Product hierarchy no. *			Part no.	SBU	Type / Description	Customer part no.
SBU PG	PGU	Type				
02 006	017	0000001601	See list below	Power Entry Module with Filter	EF12

New internal wiring.

EF12					0118.2264	
creation date	created by	release date	released by	notification no.	revision	page
2015-01-19	huberth	2015-08-05	huberth			1 of 2

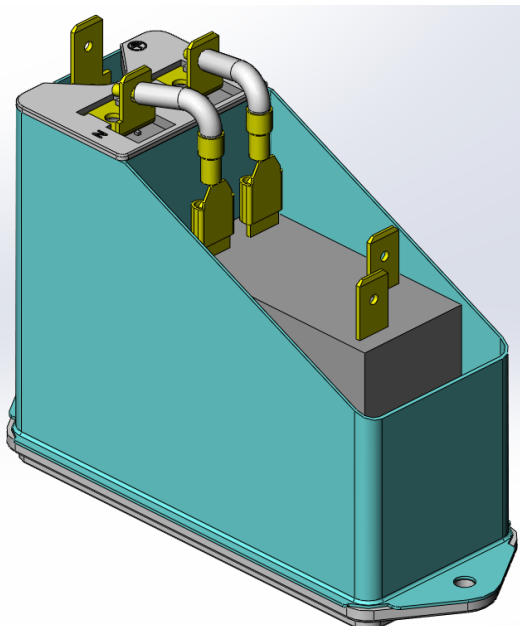
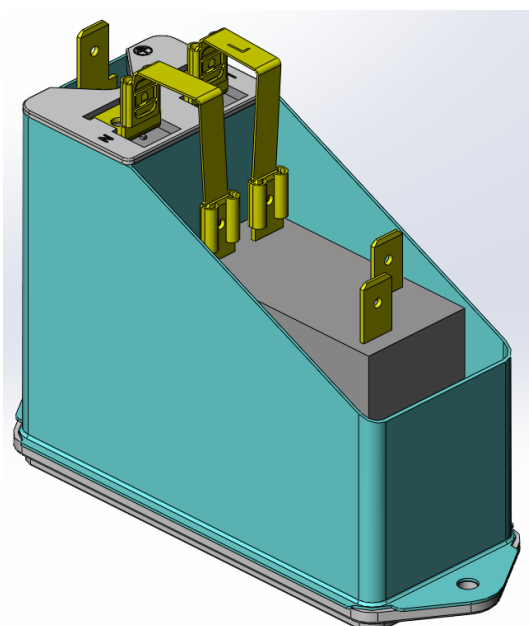
Soldered wire connection between filter and circuit breaker replaced by faston connection.

Elimination of the critical soldering process on the quick connect terminal.

Form: Yes New connection on back side, no change of outer dimensions.
Fit: No There are no dimensional changes.
Function: No This is a non-functional change.
Production Site: No There is no change of the production site.
Product Label: No There is no change on the label.
